Contract No. T201107210.01
Federal Aid Project No. EBHOS-K371(02)
BR 371A on K371 Barratts Chapel Road over Double Run
Kent County

Enclosed is Addendum No. 1 for the referenced contract consisting of the following:

NOTES AND
TYPICAL SECTION

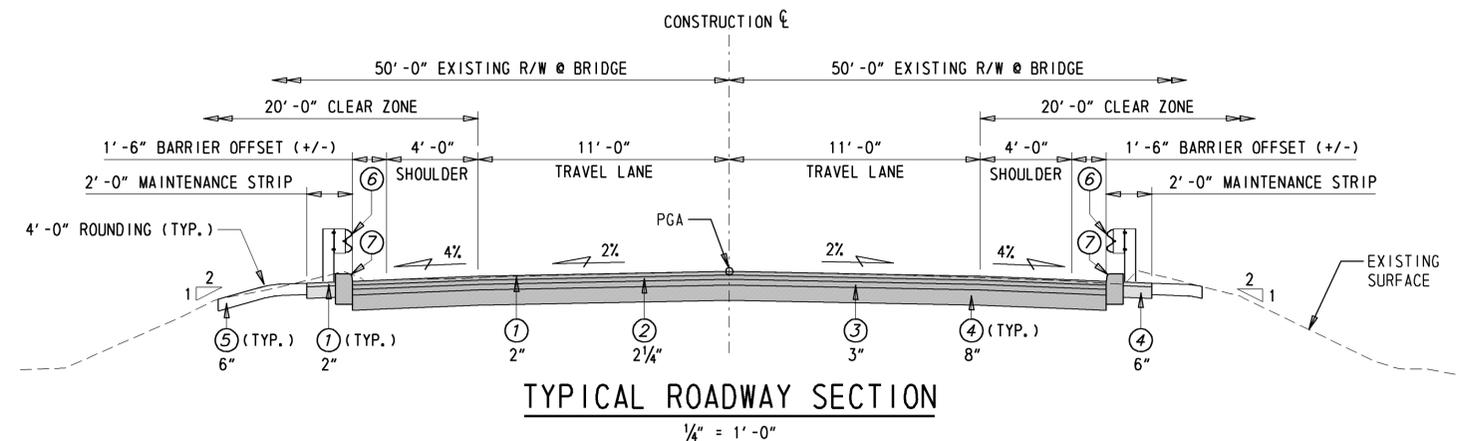
NOTE #9 ADDED. SMW 9/3/14
